UNITED STATES PATENT AND TRADEMARK OFFICE

APPLICATION NO.	FILING DATE	FIRST NAMED INVENTOR	ATTORNEY DOCKET NO.	CONFIRMATION NO.
10/802,998	03/17/2004	Ernest Rehmi Post	E-09	4404
21253	7590	08/10/2006	EXAMINER CONNOLLY, PATRICK J	
CHARLES G. CALL 68 HORSE POND ROAD WEST YARMOUTH, MA 02673-2516			ART UNIT 2877	PAPER NUMBER

Office Action Summary	Application No.		Applicant(s)	
	10/802,998		POST ET AL.	
	Examiner		Art Unit	
	Patrick J. Connolly		2877

DETAILED ACTION

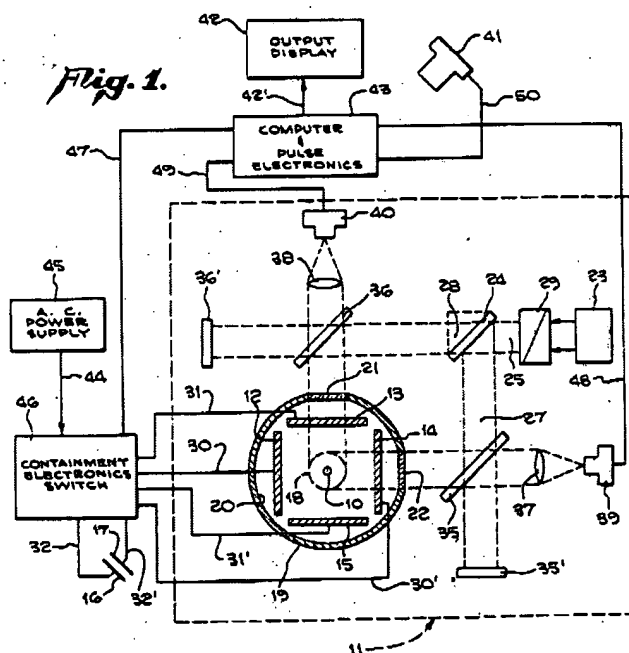
As to **claim 1**, Browning discloses a dynamically restrained inertial reference instrument and reliability sensor including (see Figure 1 below):

an electrodynamic trap (spherical containment space: 18) for suspending a particle (10);
and a readout device (computer, electronics and output display: 42, 43) for measuring variations of the particle when said trap is subject to acceleration (see abstract).

As to **claim 2**, Browning discloses a light source (23) directed at the charged particle and means for measuring the intensity of light (detectors: 39, 40, 41; computer and display: 42, 43) scattered by the particle (see column 5, lines 45-67 through column 6, lines 1-10).

As to **claim 26**, Browning discloses a specific location of constraint for the particle (see analysis above; also Figure 1: containment space 18).
